Contribution in support of P802.3cz/D3.01 comment I-163 resolution

Rubén Pérez-Aranda, KDPOF

TDFOM vs ER, 50 Gb/s PAM4, $T_{BS} = 125C$

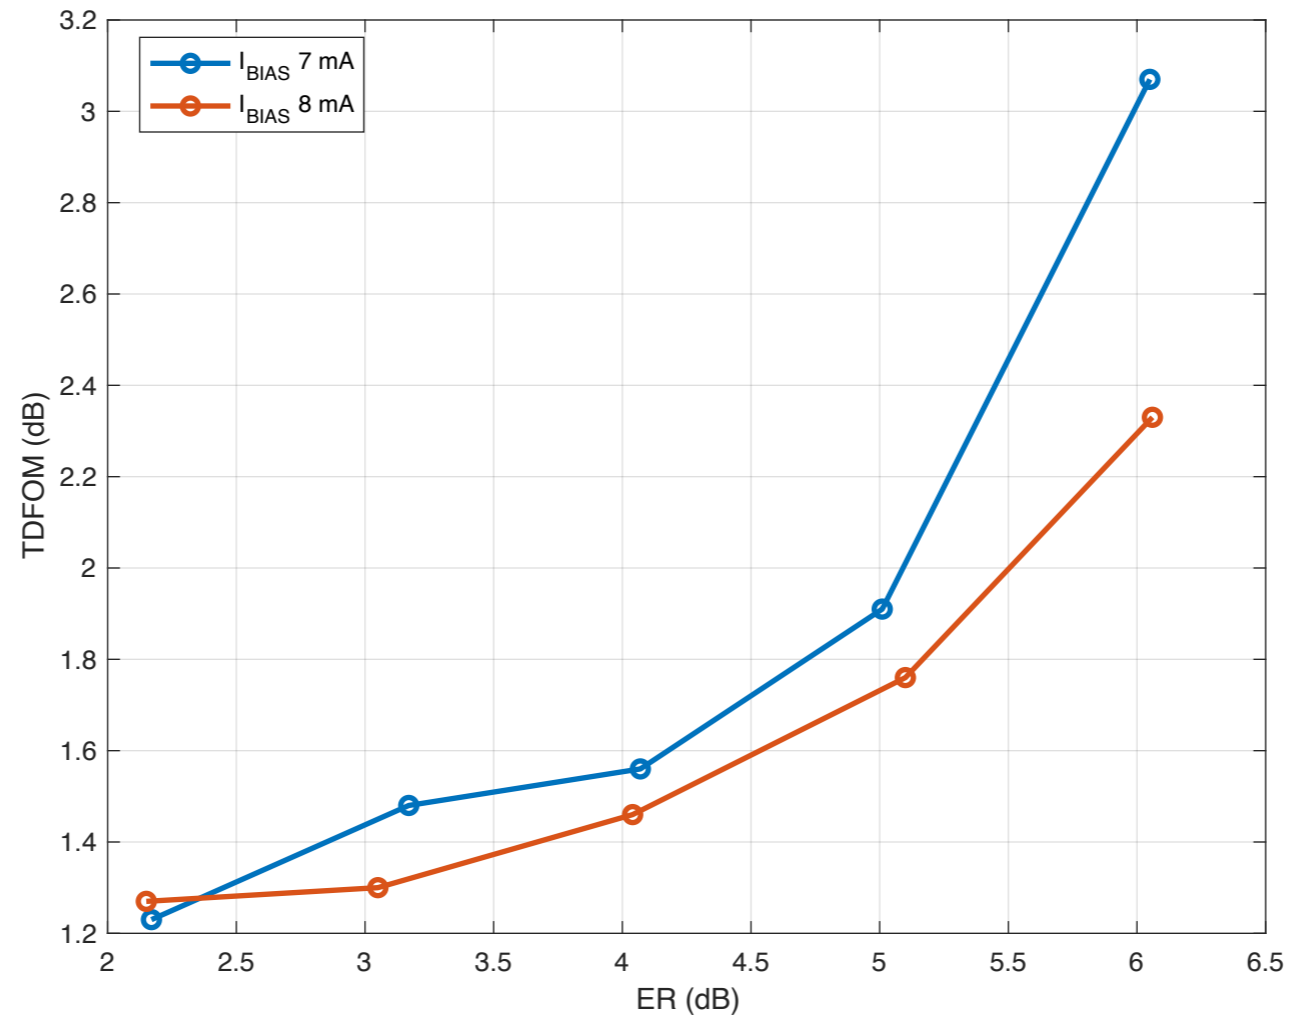
- New VCSEL E/S evaluated in the development of 802.3cz PHYs have been measured at back-side temperature 125C with different bias current and extinction ratio
- The reported TDFOM values in high ER supports the min ER of 4 dB is feasible with margin
